Response to Prof. Emmer,

Response to Referee #2,

Comments on "A mathematical model to improve water storage of glacial lakes prediction towards addressing glacial lake outburst floods" by Qi et al.

Response to Referee #3,

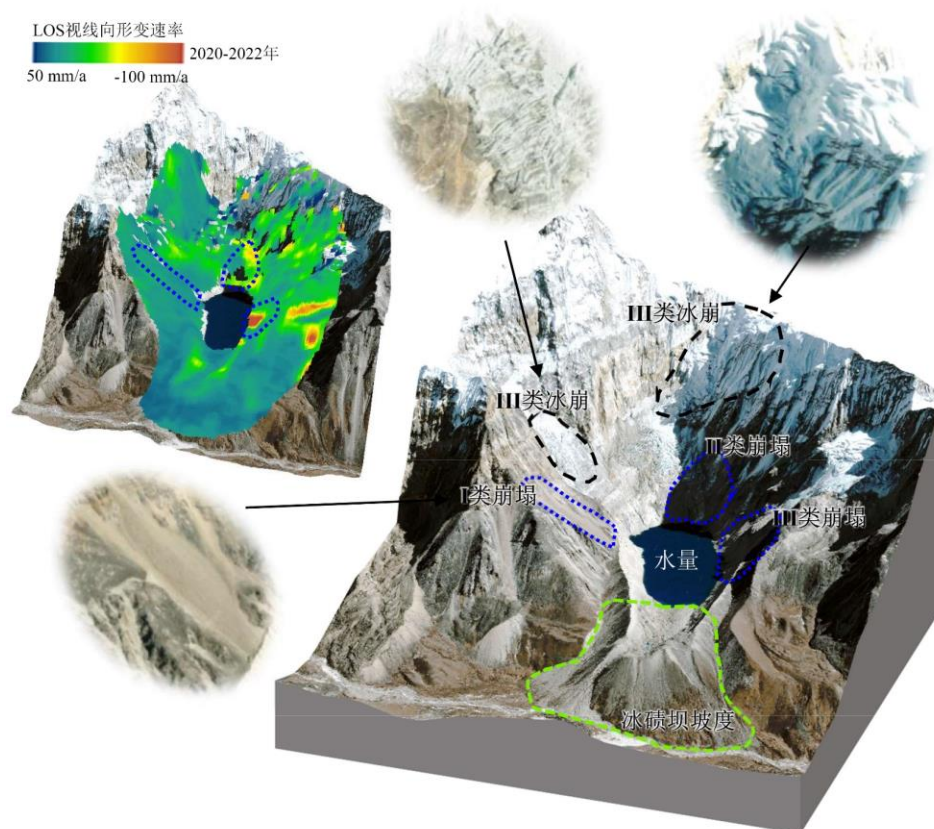
At the end, the importance of this improvement in lake volume estimation for GLOF studies (the main justification throughout the study) is unclear unless other (and much larger) sources of uncertainties in GLOF studies (e,g, coming up with realistic scenarios of GLOF triggers and GLOF mechanism, plausible breach development and dimensions, associated shape of the outburst hydrograph curve, % of lake volume release, etc.) are addressed.

Explanation and revision: Your understanding is indeed correct, and we share the same perspective. In my doctoral dissertation, we place significant emphasis on the flow processes at the dam breach, as well as the triggering factors for moraine-dammed lake outburst floods, such as ice falls, snow avalanches, and landslides entering the lake, which generate waves and ultimately lead to the collapse of the dam. The following figures depict the reconstructed outburst flood flow process of the Cirenma Co (which experienced an outburst in southern Tibet in 1981), as well as schematic diagrams of external triggering factors for moraine-dammed lakes, such as ice falls, snow avalanches, and landslide hazard areas.

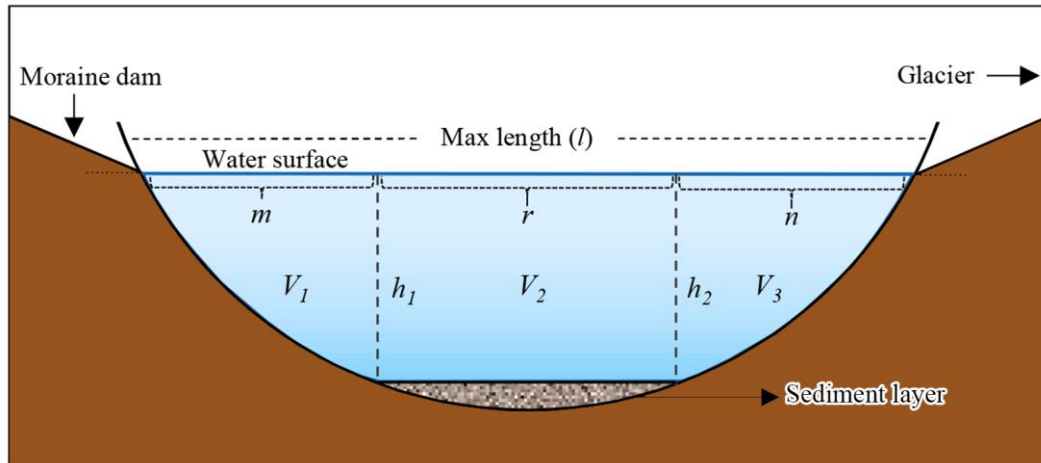
Fig. 2: please only display parameters that are further use (remove slope beta, points f and g)

**Explanation and revision:** We have revised the Figure 2.

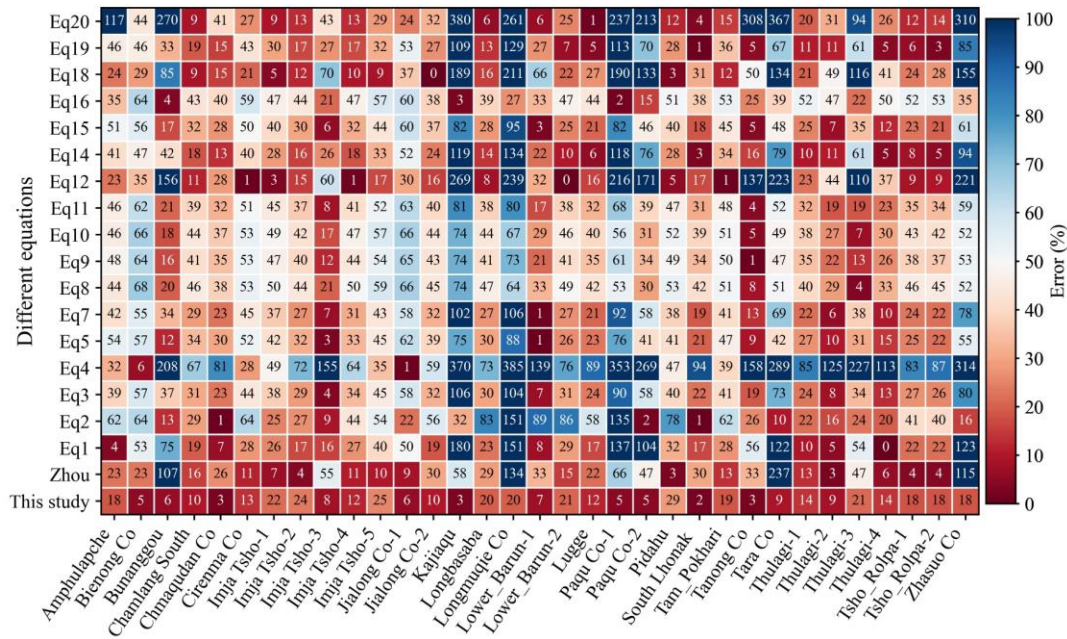
Figure 8: I don't understand what is the meaning of these box plots unless it is connected to measured data? The XY graph type (inset) is way more meaningful and the authors may consider showing a panel with performance of all methods in XY graphs.

Explanation and revision: I used box plots to represent the range of water storage estimates for each method, highlighting the differences between various approaches. Figure 8a shows significant variations among the methods, where it is clearly evident that some methods yield much larger estimates than our model, potentially resulting in order-of-magnitude discrepancies in the estimated water storage for individual lakes. The results from our model, by contrast, show a more concentrated distribution compared to the other methods. Figure 8b presents a comparison between our model's estimates and the measured values, specifically demonstrating the model's strong performance. We also experimented with other visualizations to compare the different methods, but overall, none were as effective as the box plot.

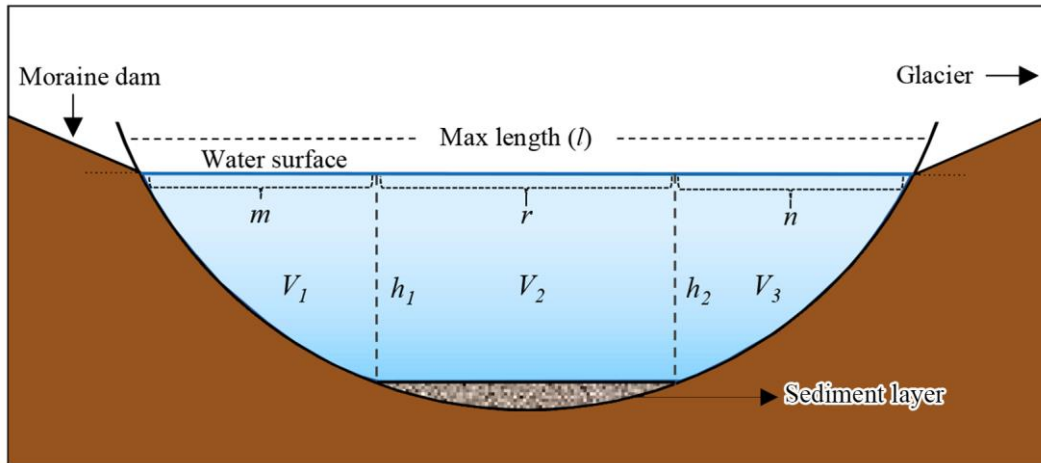
Figure 3: A small figure with the axis direction would be appreciated, as would Figure 2, which is in a yz plane according to my interpretation.

Explanation and revision: Thank you very much for your suggestion. After considering the comments from other reviewers, we have revised Figure 2. Regarding your suggestion about the axis direction, I did not fully understand the specific meaning. Could you please clarify?
